AGENDA
PLANNING AND ZONING MEETING
Norwalk City Hall, 705 North Ave
Monday, November 13, 2017
5:45 P.M.

**PLANNING & ZONING COMMISSION
AGENDA STATEMENT**

**PLANNING & ZONING COMMISSION
AGENDA STATEMENT**

SUNSET CORNER - GEOMETRIC PLAN

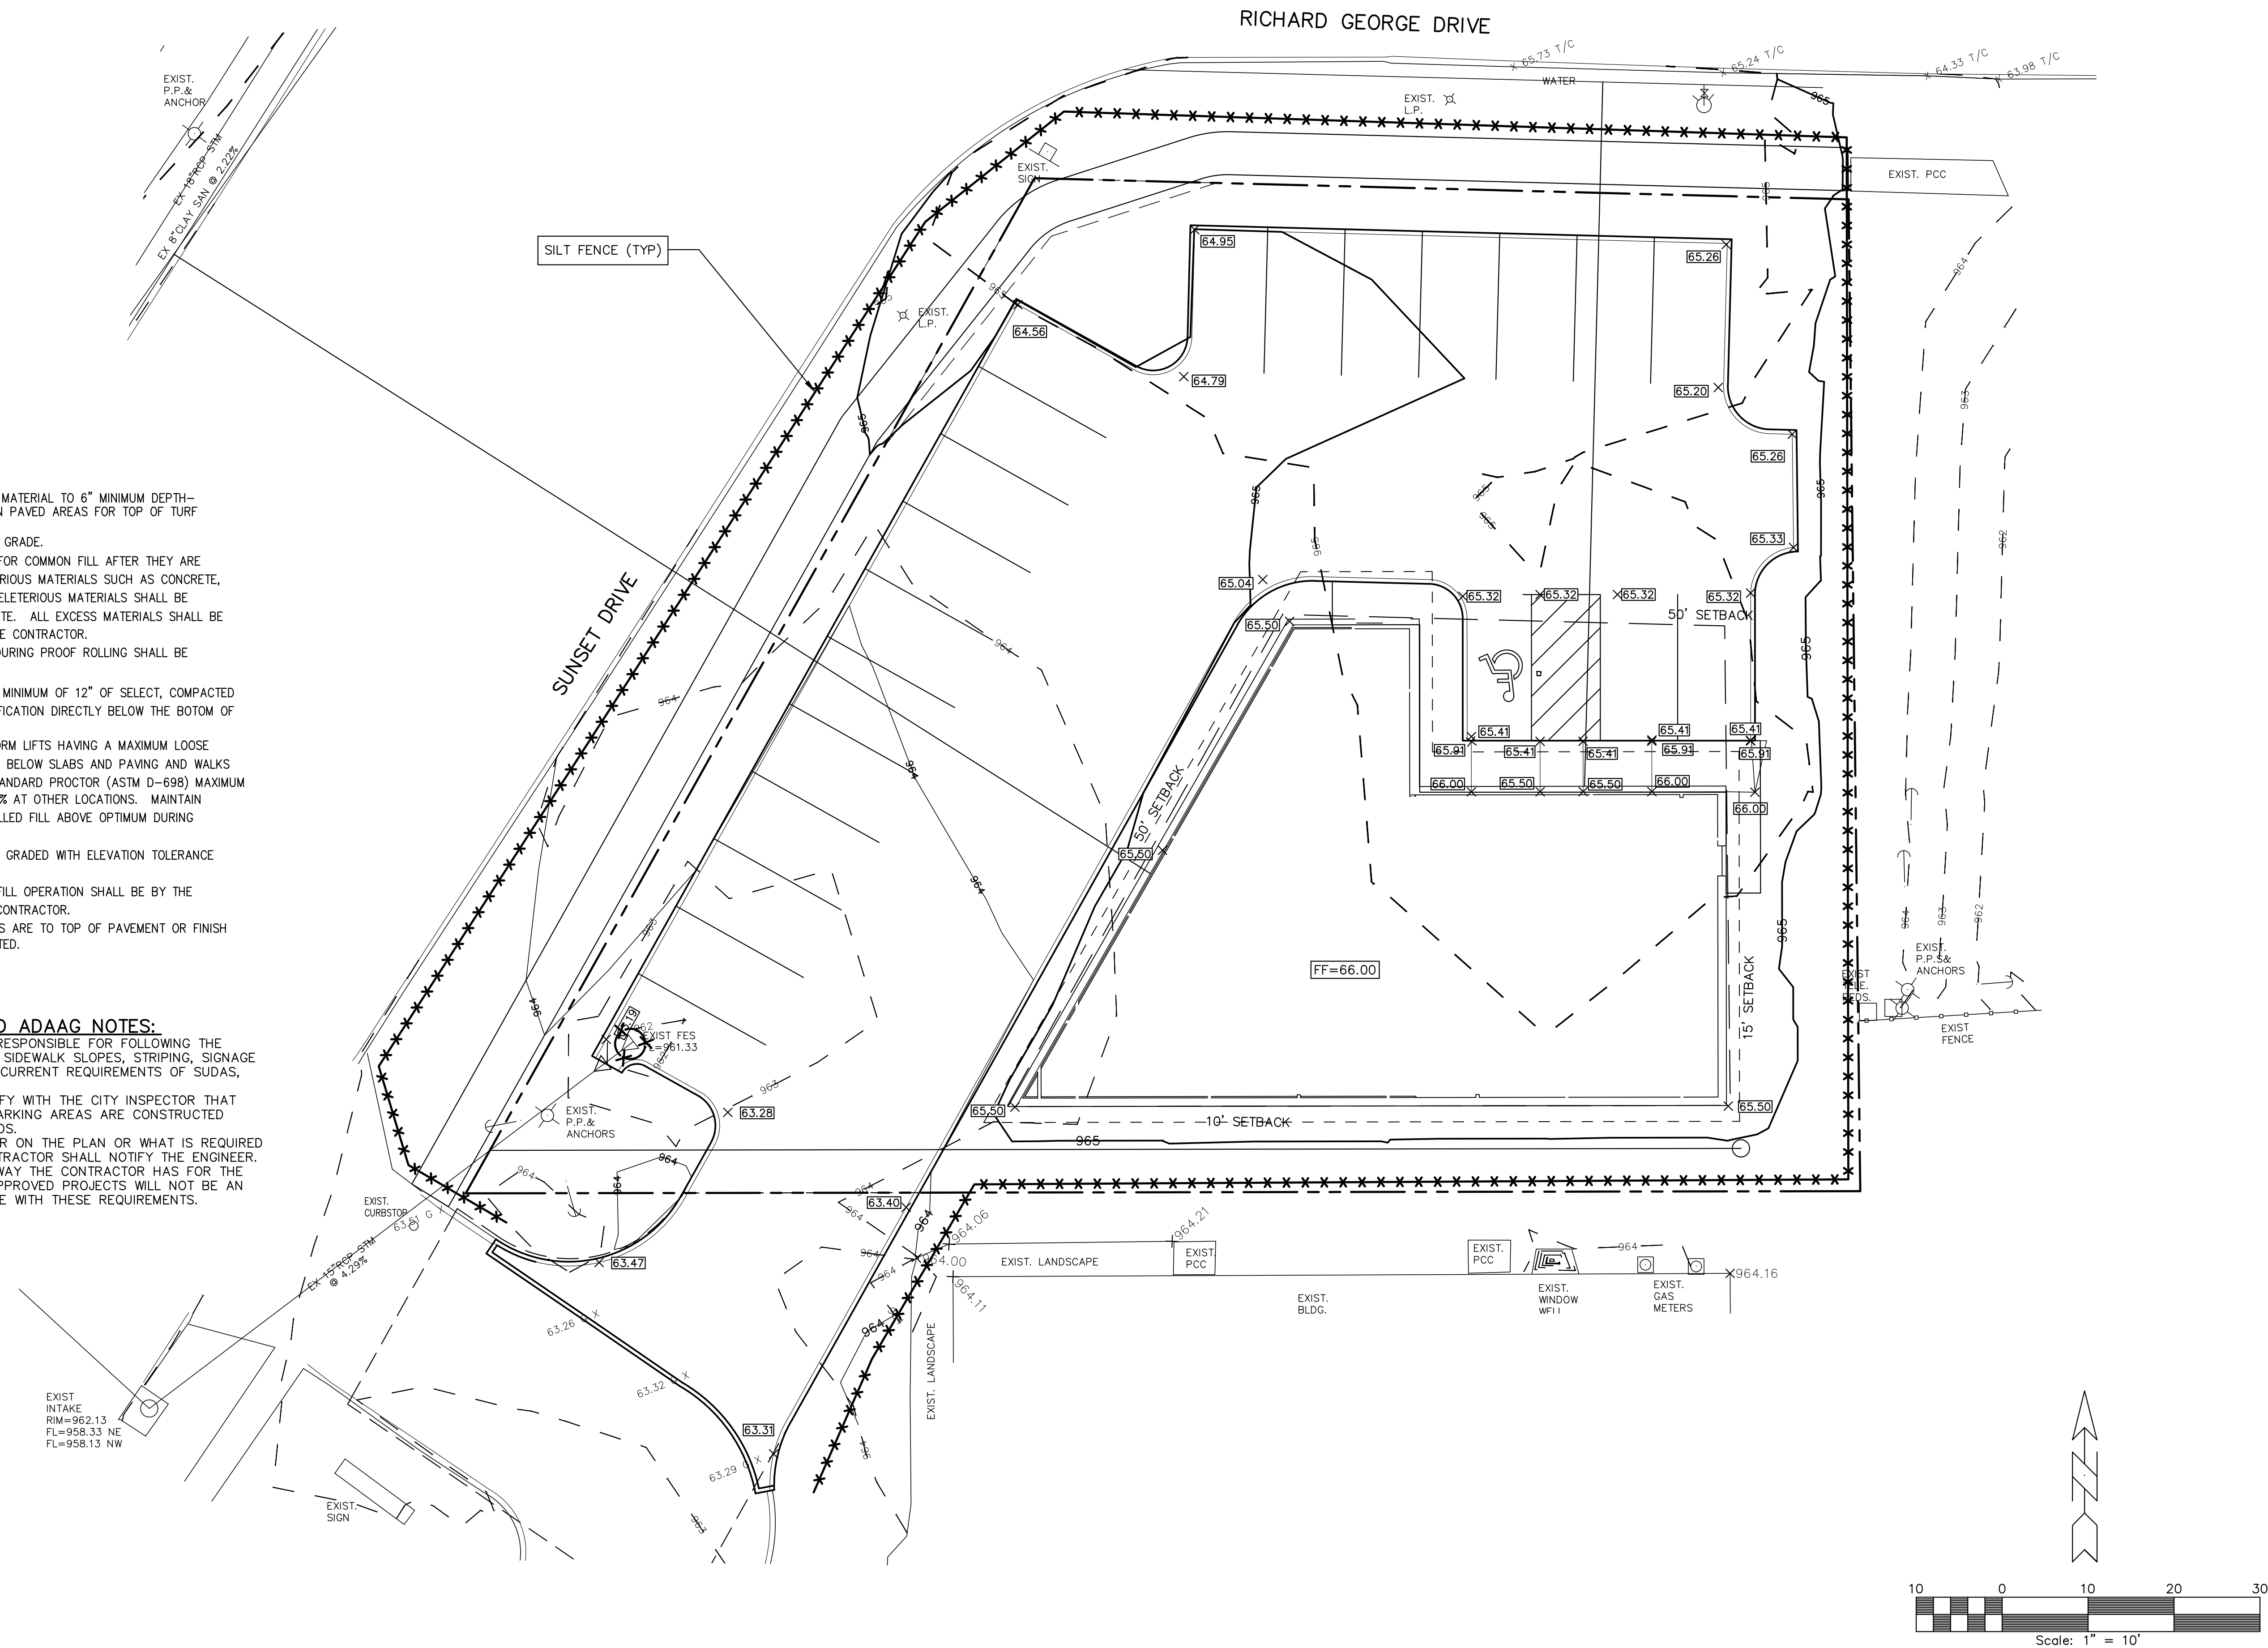
We request the 15' parking setback from public R/W be waived for this small site. Without this waiver, it is not feasible to provide an adequate number of parking stalls on this corner lot.

| STAFF ANALYSIS: | <p>Overall the site plan meets the City's requirements for development of an C-2 parcel. A variance had previously been granted for the eastern setback to allow for a 15' setback. Staff is supportive of the request to waive the parking setback requirement, which is necessary for development and the possibility of adequate parking for the office use.</p> <p>Staff is also supportive of the request to waive the onsite detention requirement. The site is small and the increased runoff will have minimal impact on the City storm sewer infrastructure and the neighboring property owners.</p> <p>The developer needs to provide a design for the rear buffer wall so that the buffer requirements are met.</p> |
| STAFF RECOMMENDATION: | <p>The staff recommends approval with the following conditions:</p> <ul style="list-style-type: none"> • That the site development and building construction follow all City code regulations. • That any significant modifications to the site plan be reviewed and approved by the Planning & Zoning Commission and City Council. • That the buffer wall be designed to meet City requirements. |

1 FRONT ELEVATION
1/4" = 1'-0"

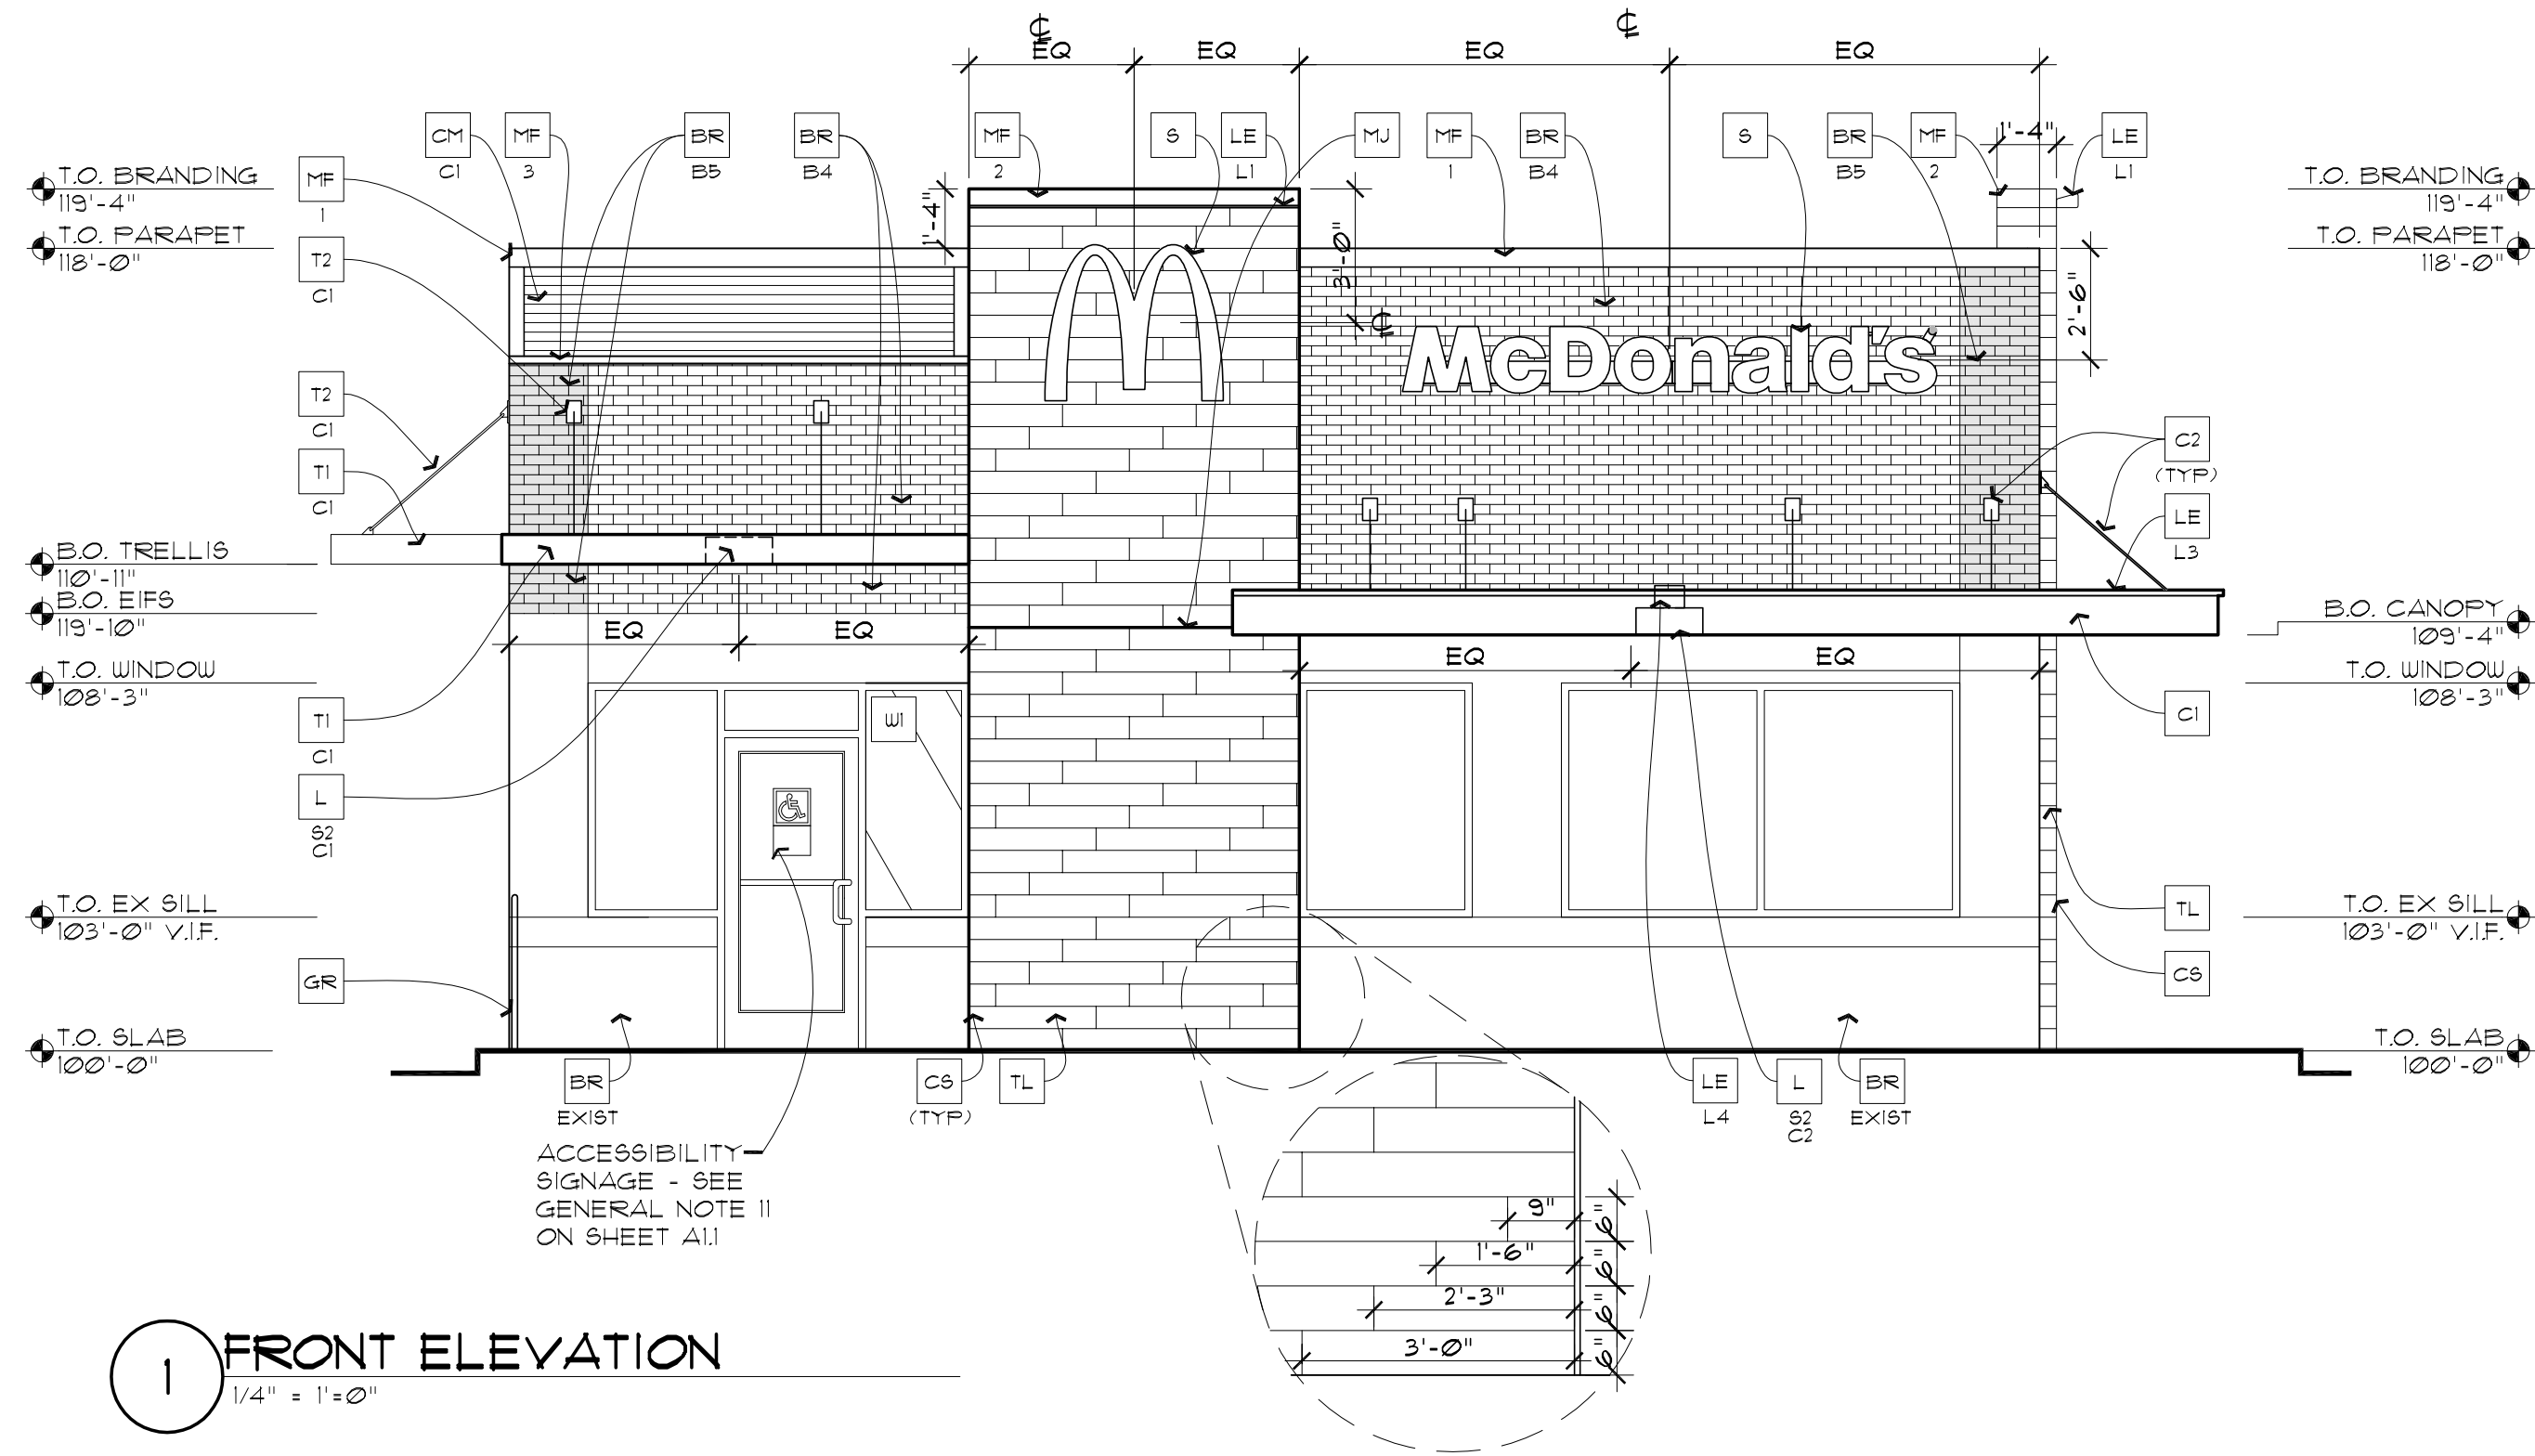
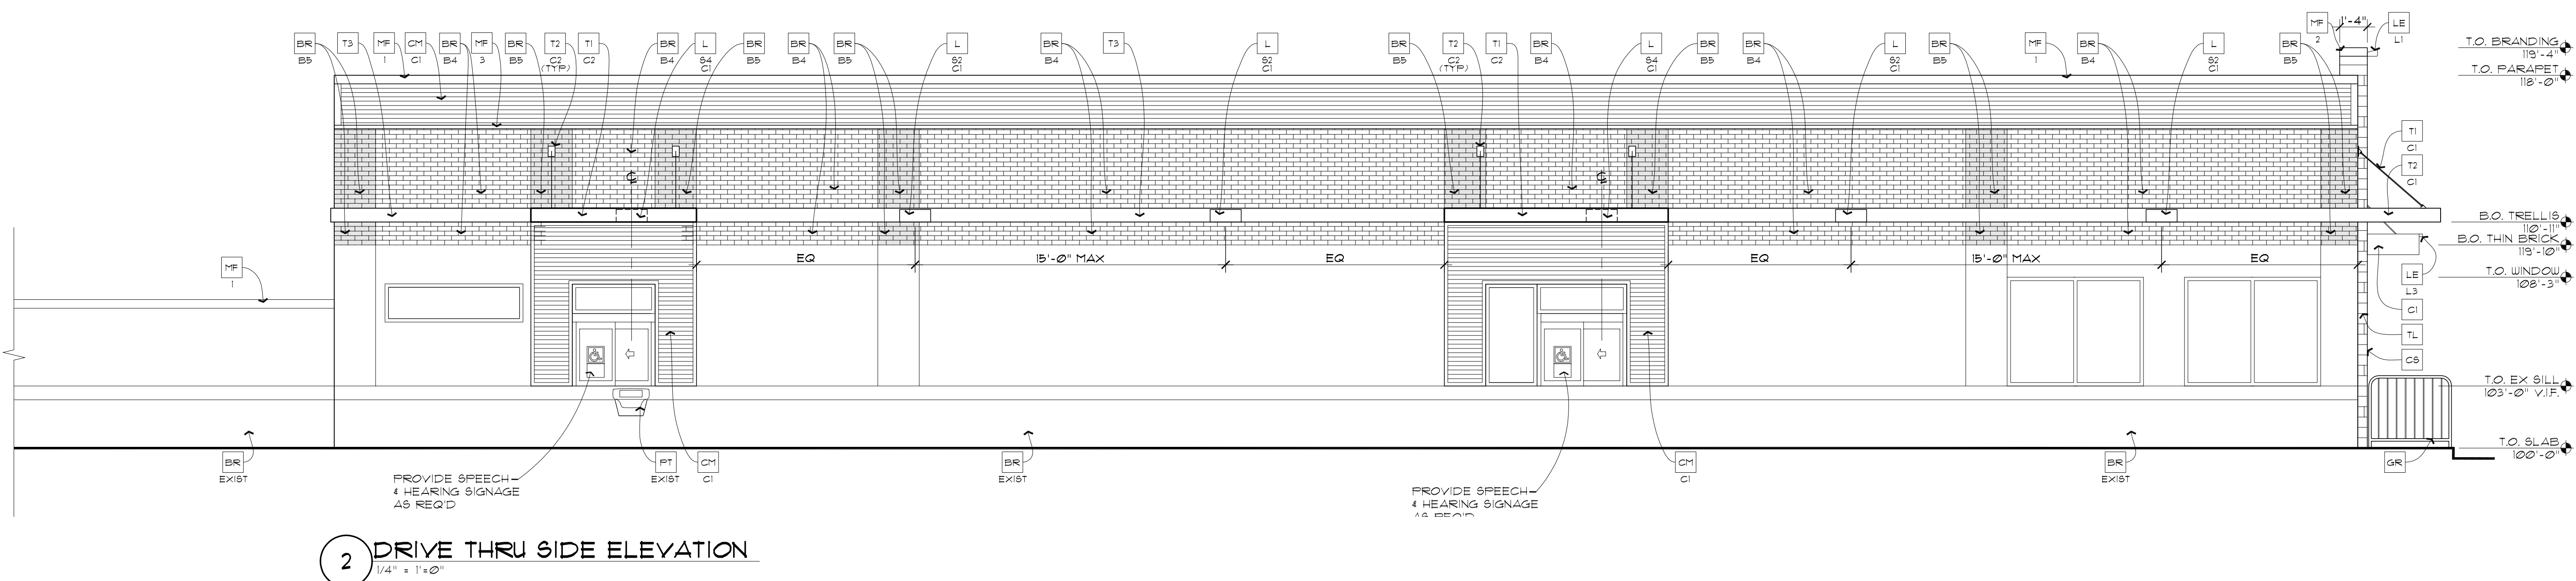
ARCHITECTURAL STANDARDS: The change in façade material is only for the upper portion of the building and consists of varying colors of thin brick. Portions around the drive thru windows are a corrugated metal panel. The design will include new entrances that are a wood patterned tile. The remainder of the building is the existing brick.

The change in façade material meets code requirements.
